STAFF REPORT 05-10-2023 MEETING

APPLICATION NUMBER: 23-8325

ADDRESS: 2998 IROQUOIS

SCOPE: ERECT HOUSE

Front (east) and side (south) elevations. Note projecting front porch. From submitted materials.

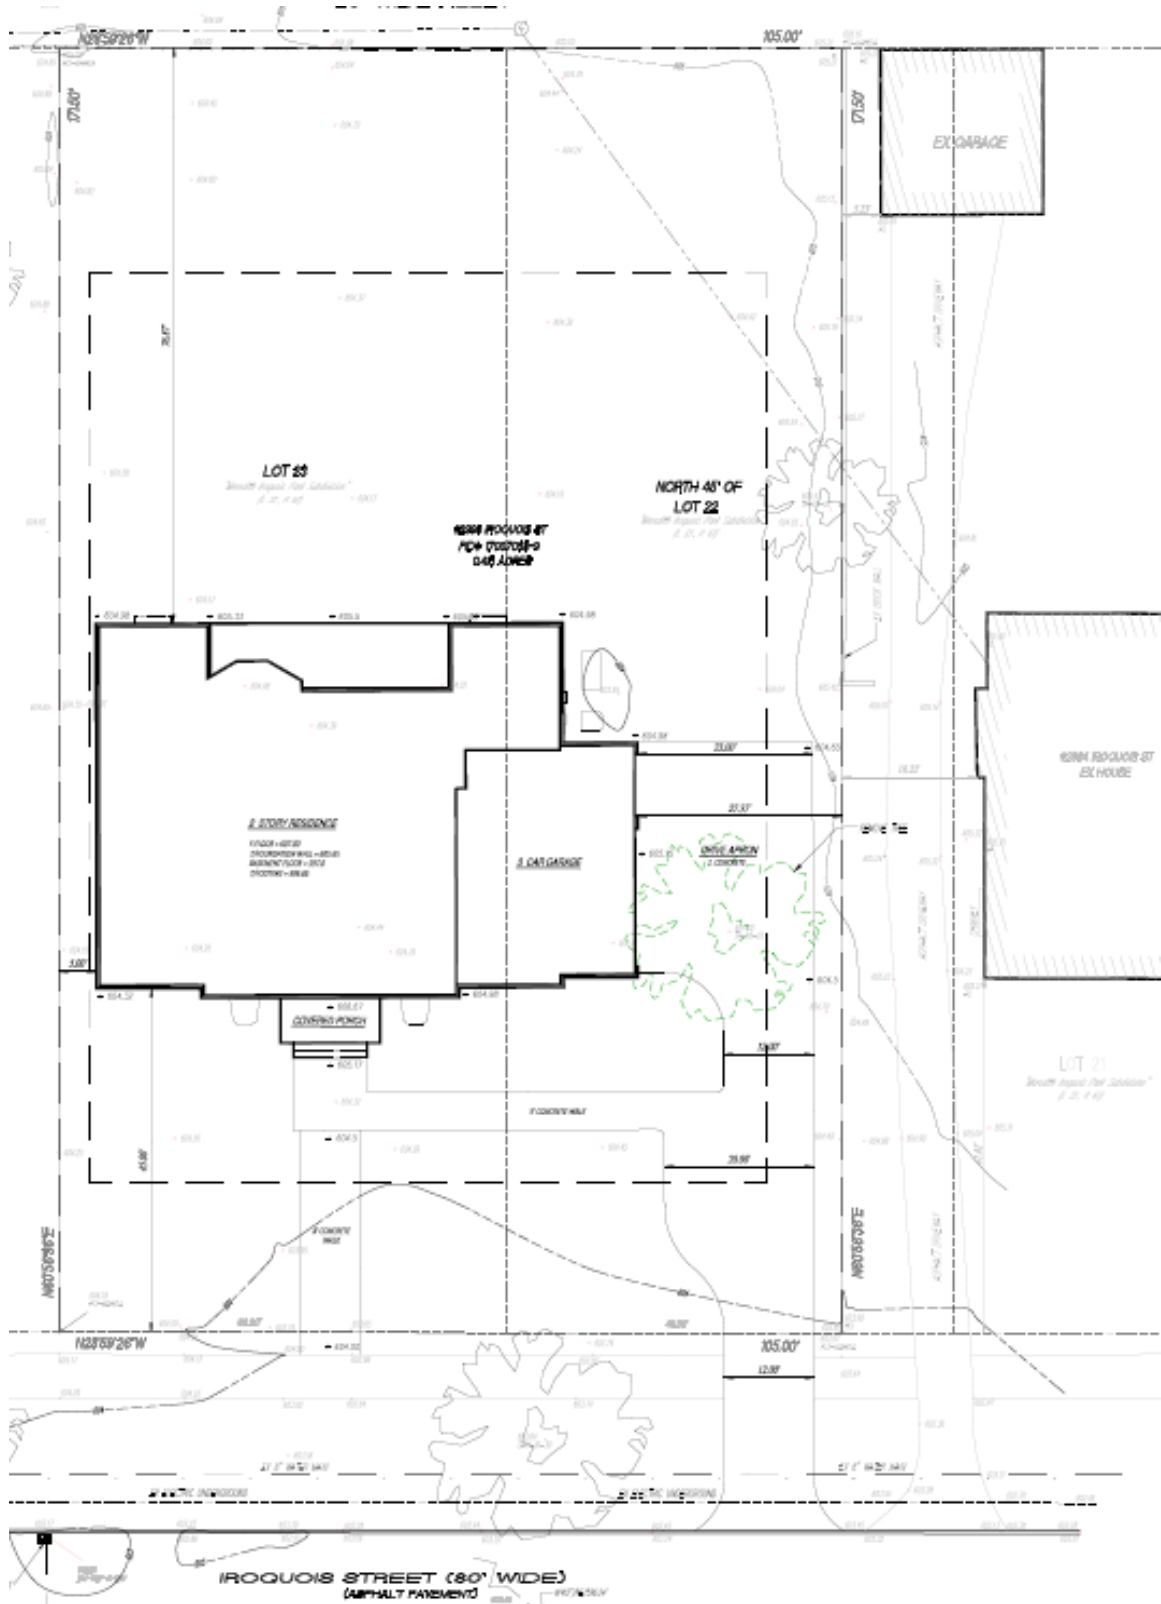
- **HDC Staff Assessment:** The front façade of 2998 Iroquois, if considered to be limited to the “core” Colonial Revival mass, is assessed by staff as compatible with the historic context. However, the flanking subordinate masses to each side (the “dependencies”) are only slightly stepped back from the setback line of the main façade. If the subordinate masses are assessed as part of the “front façade” per this Element, the front would be wider than the other homes on the block. This “horizontalizing” effect may be lessened by adjustments to the prominent roofs of the subordinate masses, discussed below.

- **HDC Staff Assessment:** The proposal at 2998 Iroquois has openings that are taller than wide, and features a arch-top window as a central design feature. These have ample precedent in the district and satisfy this Element. The flanking subordinate masses on Colonial Revival houses, discussed further below, are more typically designed as sunporches with multiple windows (i.e., a “high proportion of glass” per the ordinance language) in the district. Incorporating a single “punched” windows in these “dependencies” is somewhat atypical, and visually stretches the first story into a horizontal expression, as noted under Element 2 above.

- **HDC Staff Assessment:** The proposal for 2998 Iroquois has too many similarly gabled roof lines, in staff's opinion, especially within the limits of a classically-inspired design. Four different roofs "echo" each other at varying levels in a manner inconsistent with Neo-Georgian precedents. The resultant effect is somewhat of a mash-up between a Colonial Revival core and modern "ranch"-style book-ends. Historic Neo-Georgian houses with flanking "dependencies" (i.e., the subordinate masses to the main central mass, commonly sun rooms or sun porches) are typically flat-roofed, or low slope at most. The pronounced steep gables of the flanking masses in the proposal, in staff's opinion, do not meet this Element's requirements, as they create a horizontal effect that conflicts with the primacy of the central block and detract. The few examples of pitched roof subordinate masses in Indian Village are on much larger houses, and thereby do not conflict with the main mass. Although dormers are common in the district, and on Colonial Revival precedents, there are enough examples of houses without them for the proposed main roof design to be appropriate.

- **HDC Staff Assessment:** The proposal for 2998 Iroquois has a façade derived from Colonial Revival features and includes adequate elements. The house has a large and substantial appearance. However, as discussed above, the flanking subordinate wings or “dependencies” are problematic due to their design integration with the 1st story main façade (introducing a horizontal effect) and the prominence of their gabled roofs. Modifying these elements into multi-windowed, flat-roofed sun rooms, would address this deficiency.

- ***Indian Village Element 16, Directional expression of front elevations:*** *In general, the expression of direction is neutral.*
- **HDC Staff Assessment:** The proposal for 2998 Iroquois has a strong vertical expression in the main 2½ story core but is counterbalanced by the horizontality introduced by the flanking masses, to a degree that neutrality is not achieved. As discussed under other Elements above, revision of the large subordinate gable roofs would help address this deficiency.

- Painted elements, to include the wood clapboard, shall be per Color System C for Colonial Revival houses
- The roof shapes of the flanking masses shall be revised to be flat or low-slope, and not duplicating the gable of the primary mass. Such revision may create a two-story subordinate structure out of one of the flanking masses.

- The flanking masses shall be revised to break or recede visually from the primary Colonial Revival façade, possibly with increased setback and groupings of vertically-oriented windows similar to sun rooms that flank historic prototypes

Preliminary submission from this applicant. This is not the current design.

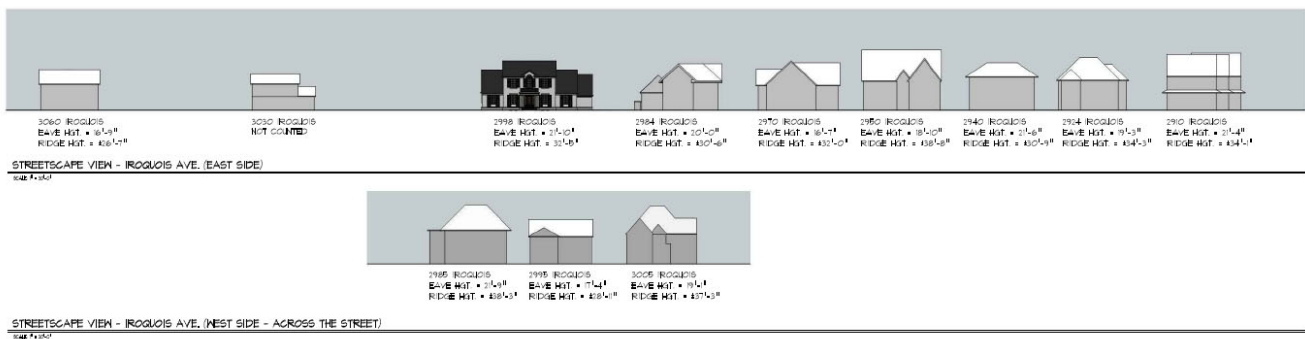
- Regarding the current proposal for 2998 Iroquois, staff met with the applicant team over the winter to discuss their preliminary proposal, shown below. Among other points, staff suggested that the proposal was too horizontal, and that a recessed porch was not consistent with the historic design elements selected. While expertly designed, the preliminary design (again, in staff’s opinion), did not fully conform to the Elements of Design, and expressed itself as a new house with traditional adornments, instead of a new house designed in the spirit of Indian Village homes.

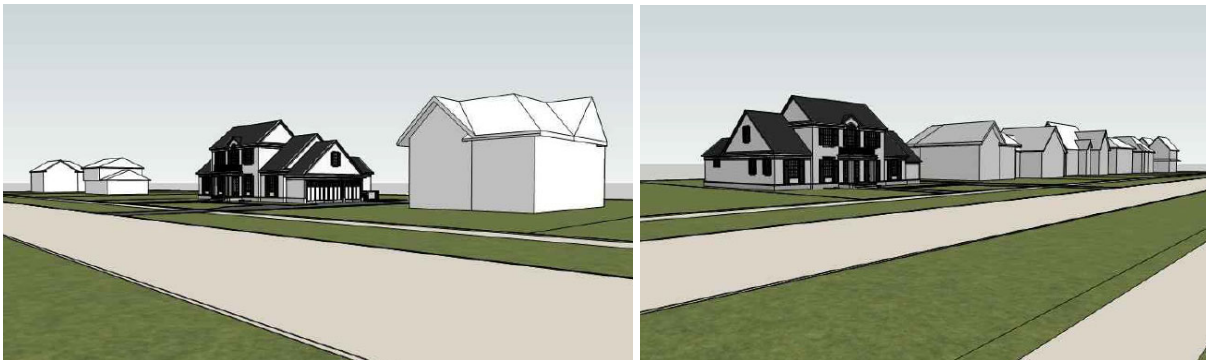
- **HDC Staff Assessment:** The proposal for 2998 Iroquois is almost exclusively of a cement fiberboard siding, a manufactured product meant to give the impression of clapboard. Boral trim (a polymer based product) is proposed in favor of traditional wood trim at the fascias. Artificial siding has a different texture and sheen than true wood, and weathers/wears differently over the years. When marked or scratched, it will take damage differently than wood. Its ability to be repainted over decades is not established, in staff's opinion. It is unlikely to age in ways similar to the true wood found on neighboring prototypes, limiting its ability to blend into the streetscape over subsequent decades. As a large home, the majority of wall surface on four elevations will be clad with this modern product. This siding profile dimensions/thickness of lapped fiber cement siding is typically too thin and does not adequately replicate a traditional lapped wood siding, which will result in an incompatible "flatness" when applied over the large wall surfaces. In some applications of these products, the lengths are shorter than traditional siding, requiring more (and more obvious) joints across the façade. In coming decades, inevitable partial repairs will be particularly noticeable, and unable to be executed with a wood "dutchman" as historic prototypes are. Larger repairs at some point decades hence may require the choice of an altogether different manufactured product if the current product becomes unavailable. Therefore, in staff's assessment, the proposed materials do not satisfy this Element. The clapboard should be of traditional wood for a primary structure in this district. Similarly all other traditionally wood elements, including window trim and the front door (as proposed), should be executed in wood.

- Traditional wood siding, with traditional detailing and paint, shall be used in areas of clapboard siding
- Painted wood shall be used in all areas for trim, including but not limited to shutters, window frames, fascias, and soffits, excepting only the porch columns. The front door and side lights shall be wood.
